Bulletin # 936
Release Date: 11-13-1996
Effective Date: 11-13-1996
Supercedes: None
Completion Date: _____
 Page 1 of 4

PRODUCT IMPROVEMENT BULLETIN

Ride Manufacturer: Dartron Industries, Inc.	Affected Production Dates: All
Ride Name: 28' Slide	Affected Serial #'s All before 602091-5A
Model #

Abstract of Issue: Super Slide 28" Lift Bar Reinforcement and Installation of Cross-Port Relief Valve.

*MIDDLE SECTION VALVING SHOWN

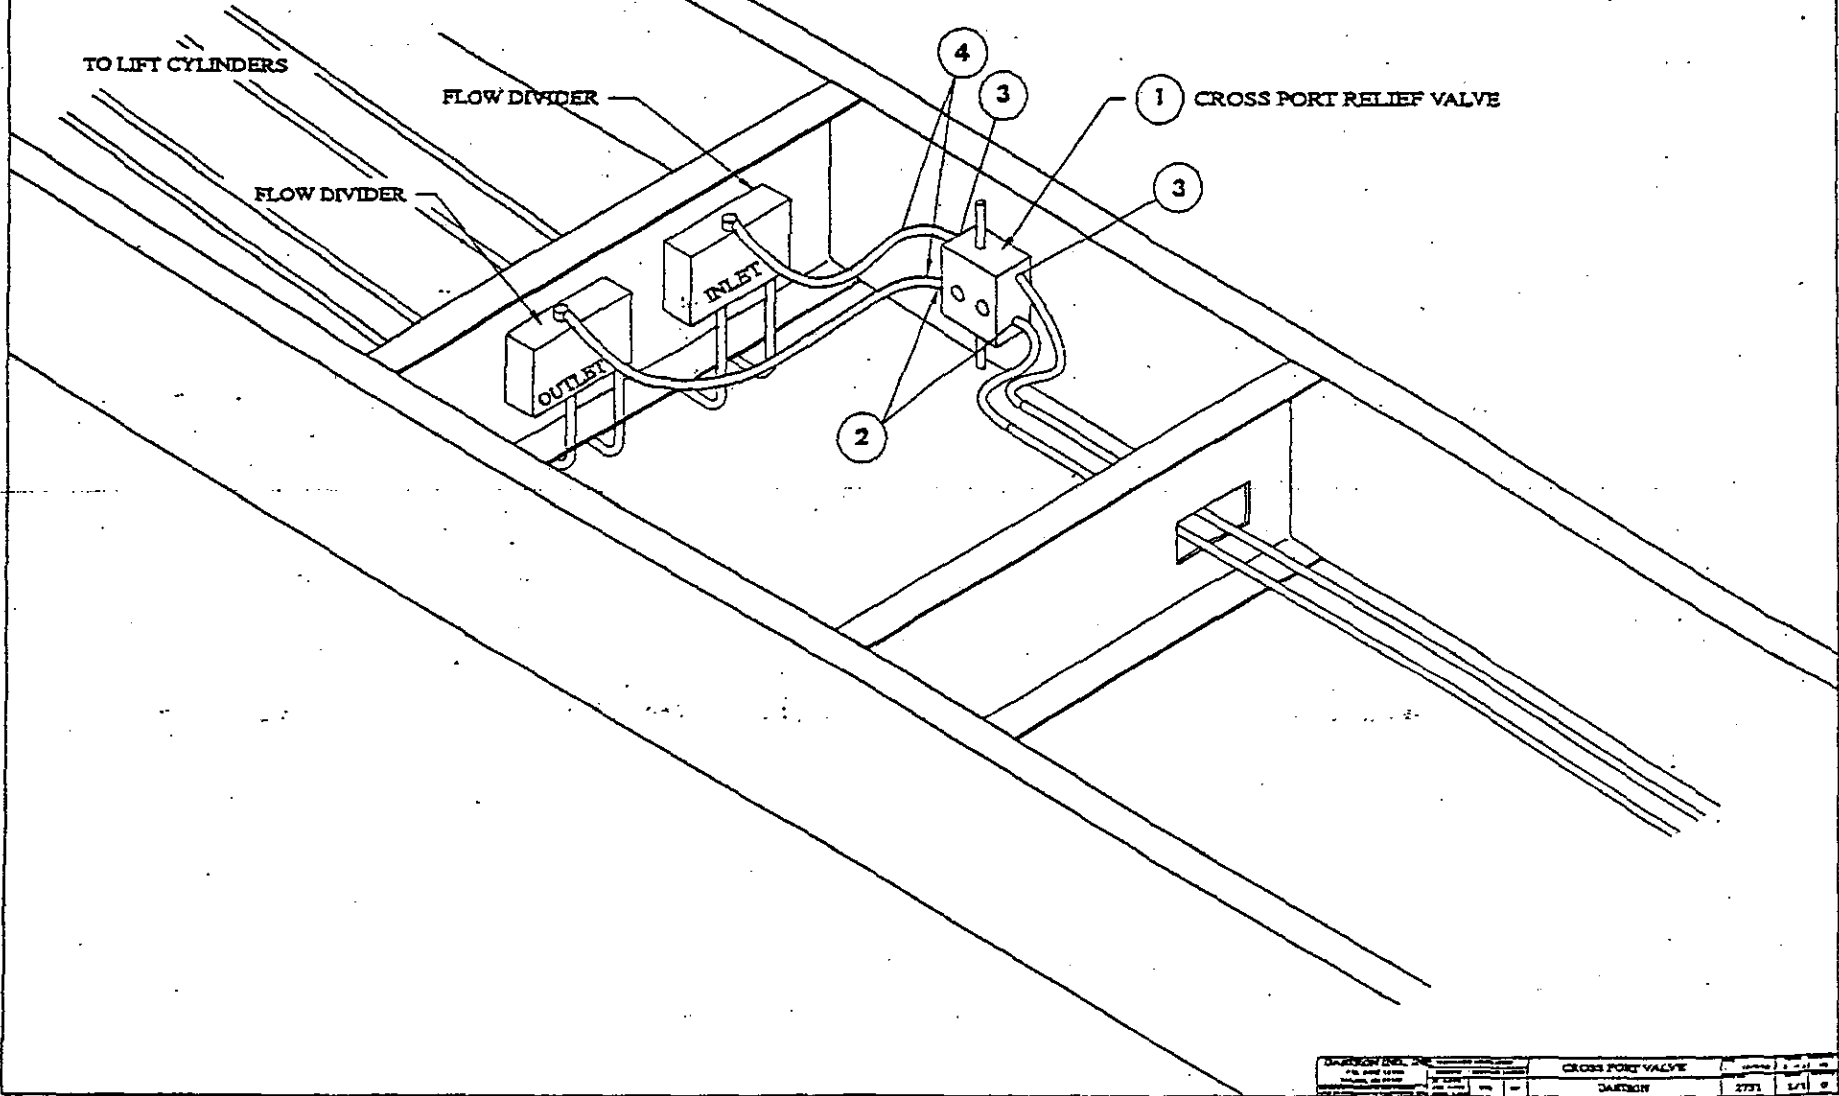
Pressure Adjustment: To adjust the pressure turn the adjusting screw all the way out until it by passes, (the slide frame won't move). Then turn it back until the frame will move without acting sluggish. Each pair of cylinders should be adjusted at the extreme ends of their stroke. This will provide the minimum pressure required to move the frame adequately.

- > Lifting pressure-800 lbs.
- > Down pressure-700 lbs.

- > Lifting pressure-1200 lbs.
- > Down pressure- 800 lbs.

* LIFT BAR REINFORCEMENT

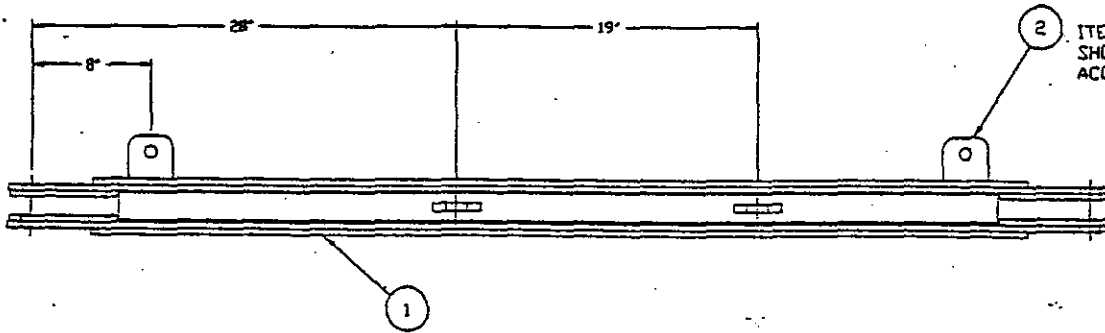
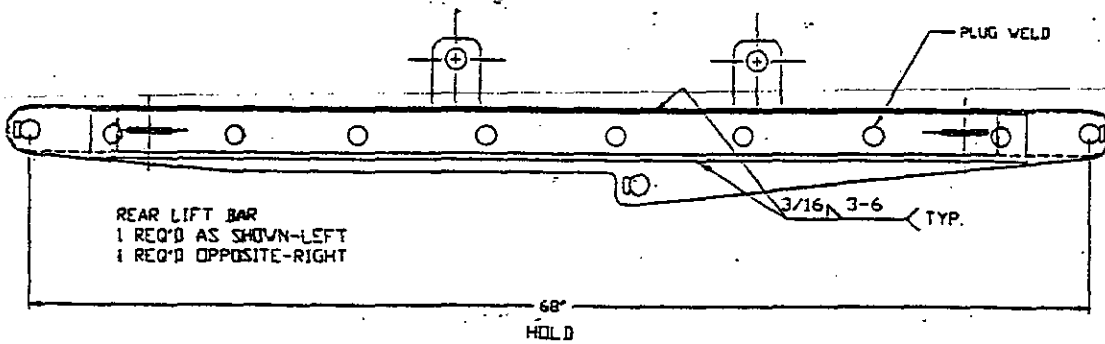
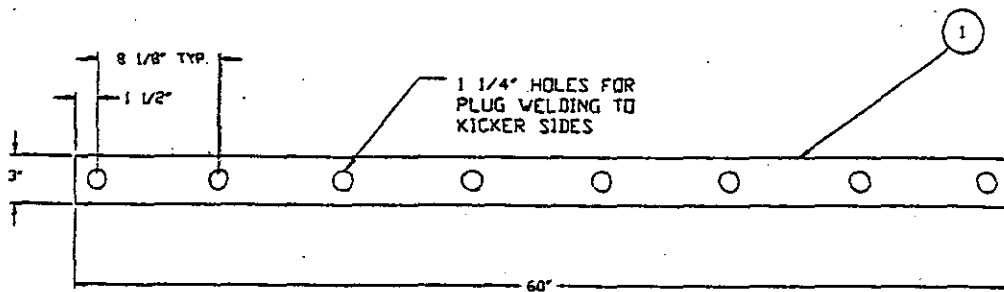
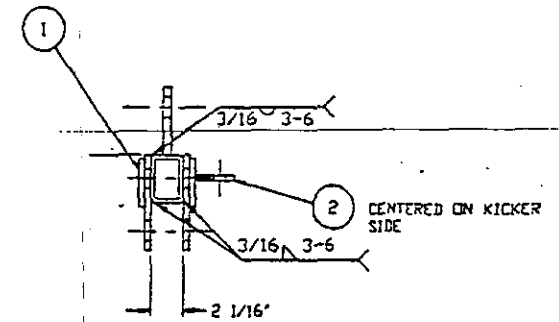
ITEM 2 HAS BEEN
SHORTENED 3/8" TO
ACCOMMODATE ITEM 1

- STEP 1: REMOVE ITEM 2 FROM SIDE OF LIFT BAR
- STEP 2: STRAIGHTEN LIFT BAR IF NEEDED
- STEP 3: POSITION ITEM 1 CENTERED ON BOTH SIDES OF LIFT BAR. THEN STITCH WELD AND PLUG WELD.
- STEP 4: LOCATE AND WELD ITEM 2 TO SIDE OF LIFT BAR.

REAR LIFT BAR
1 REQ'D AS SHOWN-LEFT
1 REQ'D OPPOSITE-RIGHT

- > Reinforce the two lift bars in accordance with drawing # 2751 attached.
- > Install cross port relief valve in accordance with drawing # 2751 attached and the following instructions:
 - Valve location:** See attached sketch a. An exact location is not required. Just make sure hose attachments and valve adjustment is accessible. This is typical for both the middle section and upper section hydraulic cylinders.
 1. Drill and tap holes 5/16"-8 at desired location of valve.
 2. Mount valve using 5/16"-8 x 2 lg. grade 5 bolts with lock washers.
 - Valve Plumbing:** Remove inlet and outlet hydraulic hoses from flow dividers and attached to cross-port relief valve. Using the supplied hoses, connect cross-port relief valve to inlet and outlet flow dividers.
